**The Commerce Commission 'Powerco Customised
Price-quality Path' Draft Decision' consultation
paper:**

Date: 15 December 2017

Powerco’s response

Figure 1: Illustrative example of proposed unplanned quality path

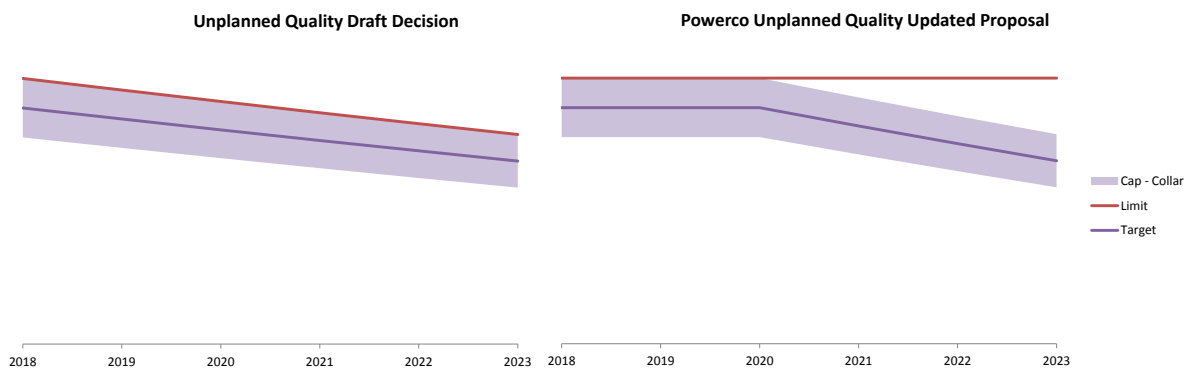
The draft decision states that the reduction in the unplanned quality path would begin from year 1 in the CPP period. We disagree with this timing and propose an two year period where the quality target is not reduced from the historical average, with the target then reducing from year three of the CPP period on.

The impact of our proposal for the delayed quality path reduction, and using the historical limit for non-compliance assessment, is shown illustratively below.

To reduce the likelihood of non-compliance with the quality limit to a level we believe is realistically achievable; we therefore propose that the unplanned SAIDI and SAIFI limits for assessing quality path compliance (the two out of three test) be retained at a 10-year

In view of the above, we propose the Commission reduces the targeted reduction in unplanned SAIDI and SAIFI to 5% and 2.5% respectively.
